PLANNING & DEVELOPMENT COMMITTEE

8TH MARCH 2018

APPLICATION NO: 17/0525/38 - Proposed revised restoration scheme following completion of coal extraction pursuant to Condition 8 of planning permission reference 13/0466, incorporating formation of a plateau for future development in accordance with Policy NSA8 of Rhondda Cynon Taf Local Development Plan, at opencast site, Tower Colliery. (Amended site and section plans, drainage details and new photo montages dated October 2017), Tower Colliery Railhead, Rhigos Mountain Road, Rhigos, Hirwaun, Aberdare, CF44 9UF

Drawing title		OBJECTION 081 TOWER REGENERATION LTD NANT Y BWCH WATERCOURSE REALIGNMENT PROPOSAL				
Drawing status		FOR INFORMATION				
Scale		1:2000 @ A1				
Jacobs No.		B2191100				
DO NOT SCALE FROM THIS DRAWING

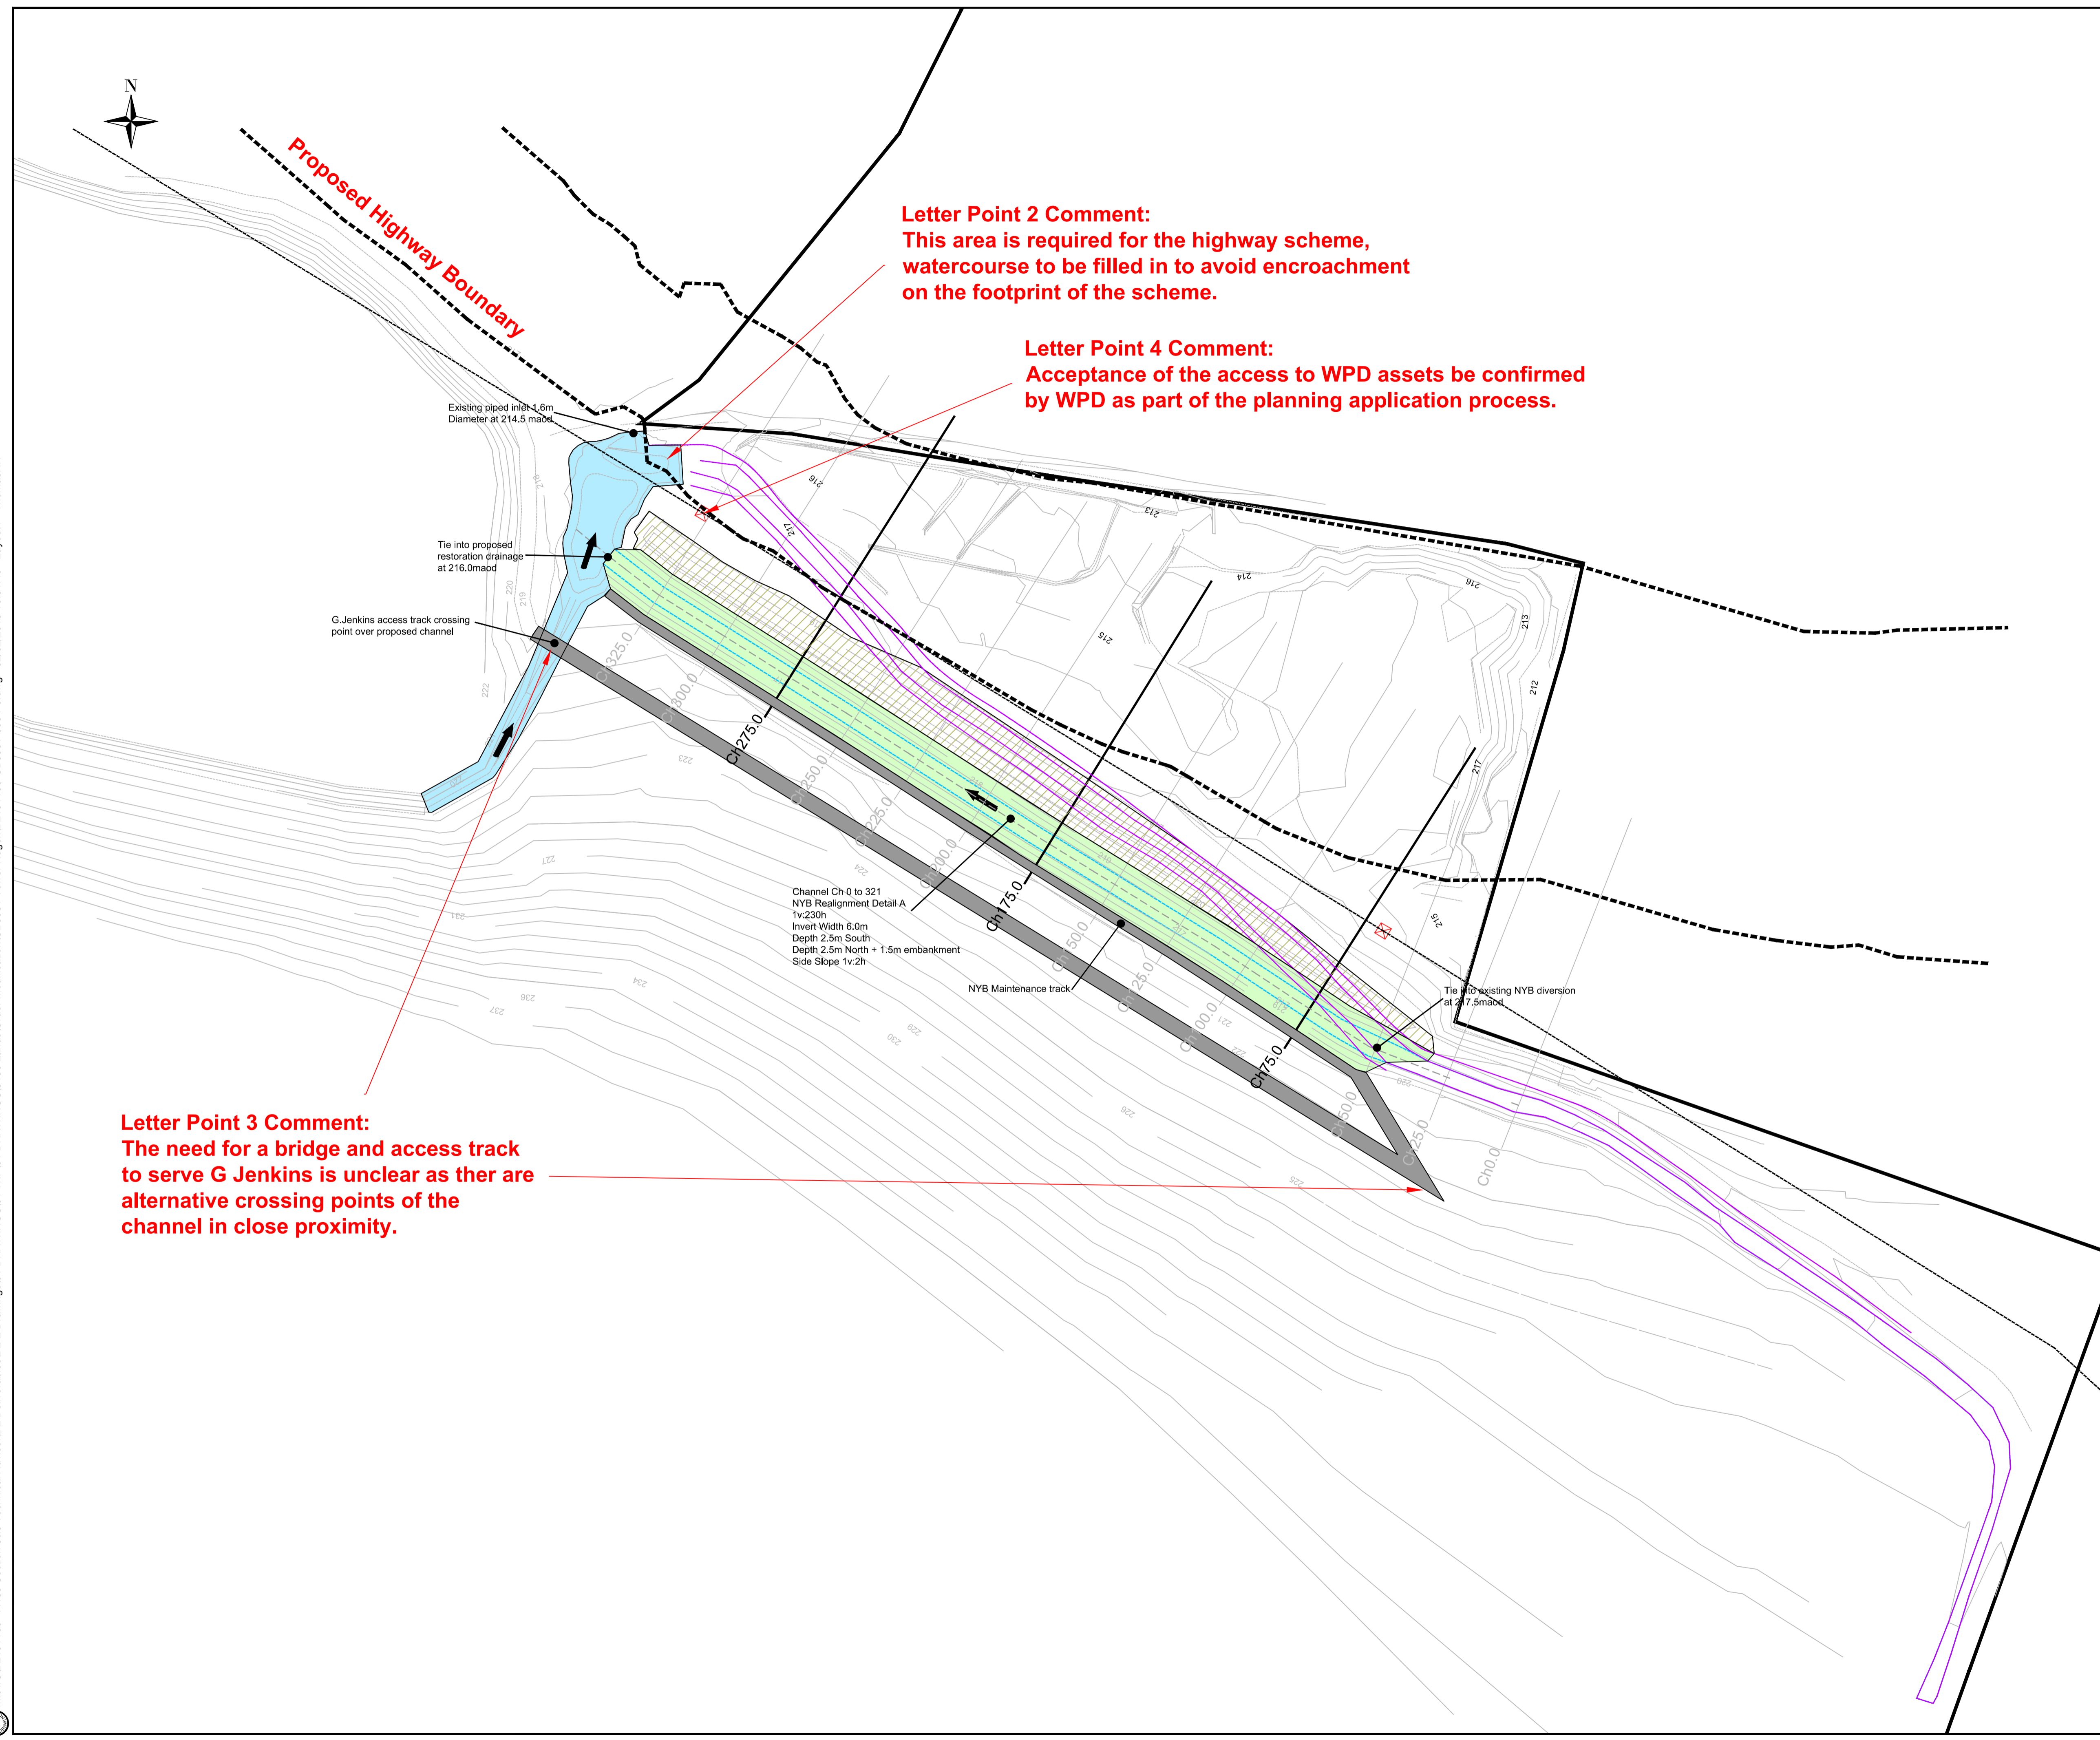
1. The route of the proposed re-alignment of the Nant Y Bwch watercourse, as set out in the aforementioned plan, is acceptable in terms of avoiding impact on the A465 scheme.
2. The length of the existing watercourse to be stopped up needs to be extended to avoid encroachment on the footprint of the scheme, see attached plan for details.
3. The need for a bridge and access track to serve G Jenkins is unclear as there are alternative crossing points of the channel in close proximity.
4. Western Power Distribution (WPD) will need to be consulted as part of your planning application to ensure access provision to their assets is acceptable. Access to WPD assets will not be granted from the Trunk Road.
5. The planning application (10/0292/10 granted 16 December 2011) clearly states that it was always the intention to return the diverted Nant Y Bwch watercourse to its

Letter Point 2 Comment:
This area is required for the highway scheme, watercourse to be filled in to avoid encroachment on the footprint of the scheme.

Letter Point 4 Comment:
Acceptance of the access to WPD assets be confirmed by WPD as part of the planning application process.

Letter Point 3 Comment:
The need for a bridge and access track to serve G Jenkins is unclear as there are alternative crossing points of the channel in close proximity.

Subject to amendments relating to points raised above we approve the proposed re-alignment of the Nant Y Bwch watercourse. Please do not hesitate to get in touch if you wish to discuss any of the points raised in this letter.
